BOARD MEETING AGENDA

Coon Creek Watershed District Offices - Board Room
Monday, July 22, 2024, 5:30 p.m.

- 8. P24-027 Universal Services**
- 9. P24-010 Xylite Building**

Figure 3: Erosion & sediment control plan

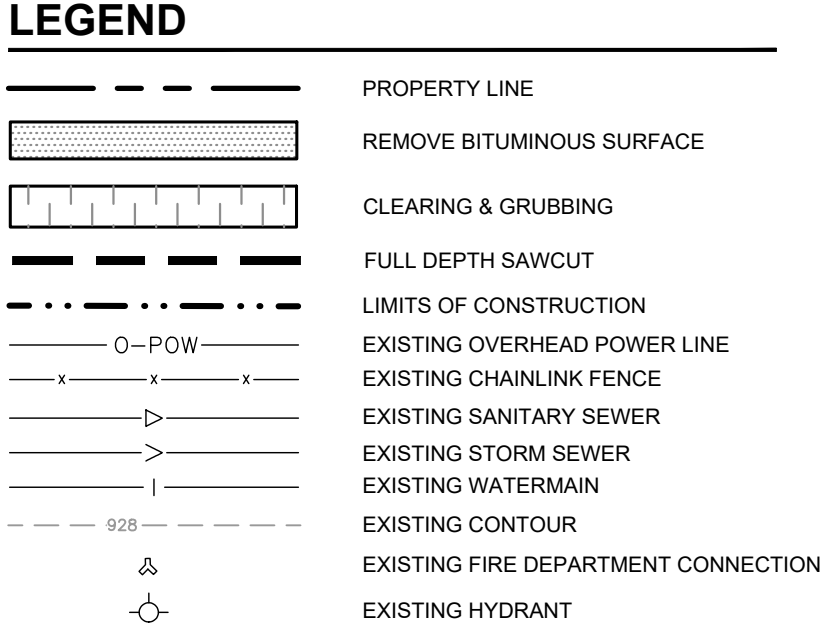
3. Update the erosion and sediment control plan to include the following:
 - a. Update construction sheet C301 to show rock construction entrance as indicated in SWPPP.

b. Show inlet protection on sheet C301 as needed.

Figure 3: Erosion & Sediment Control Plan

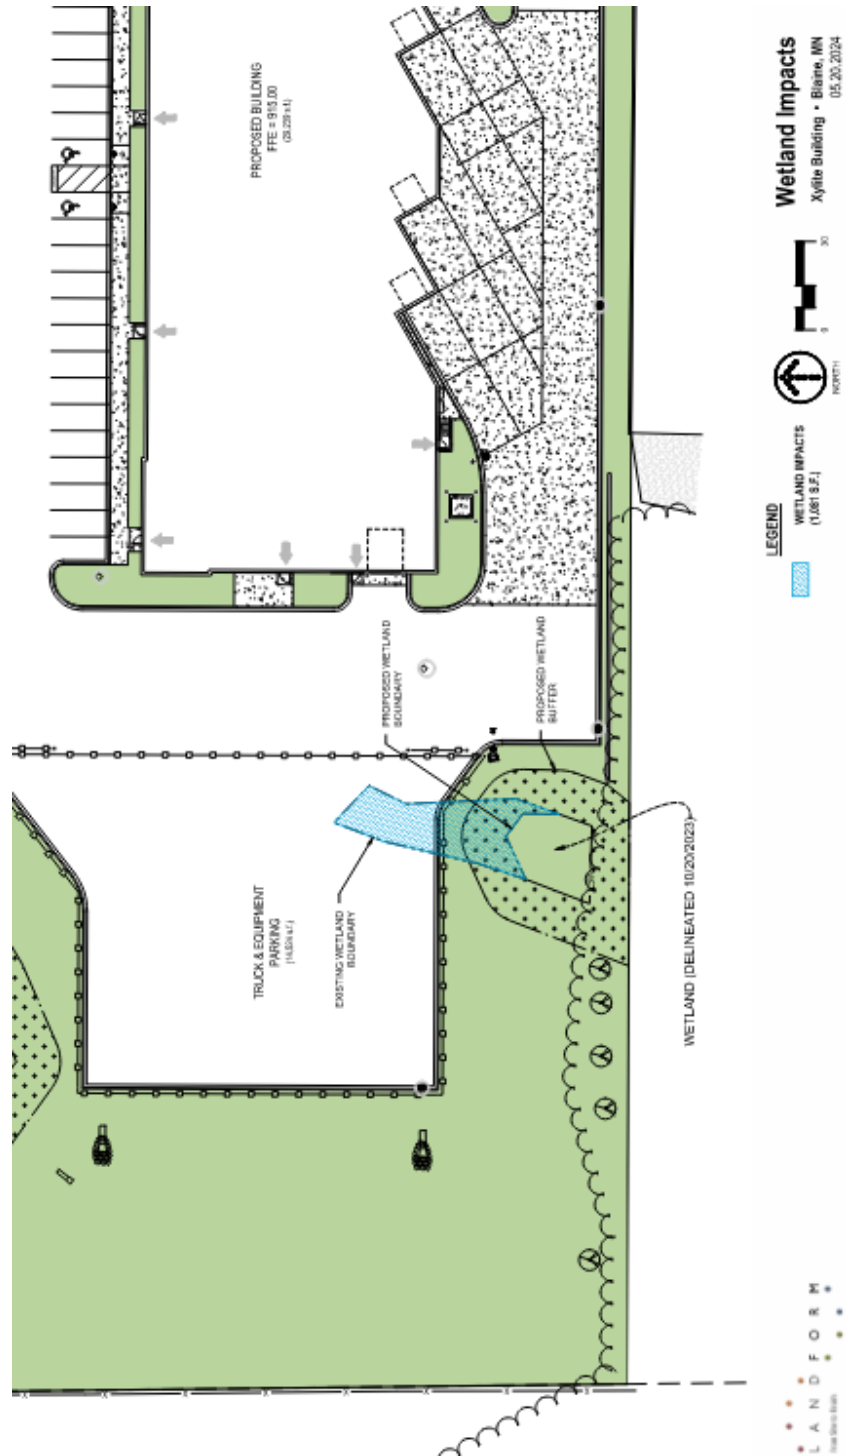
3. Update Erosion & Sediment Control Plan to include the following:
 - a. Update construction plan set Sheet C3.4 - Stabilize Soils to stabilize soil and soil
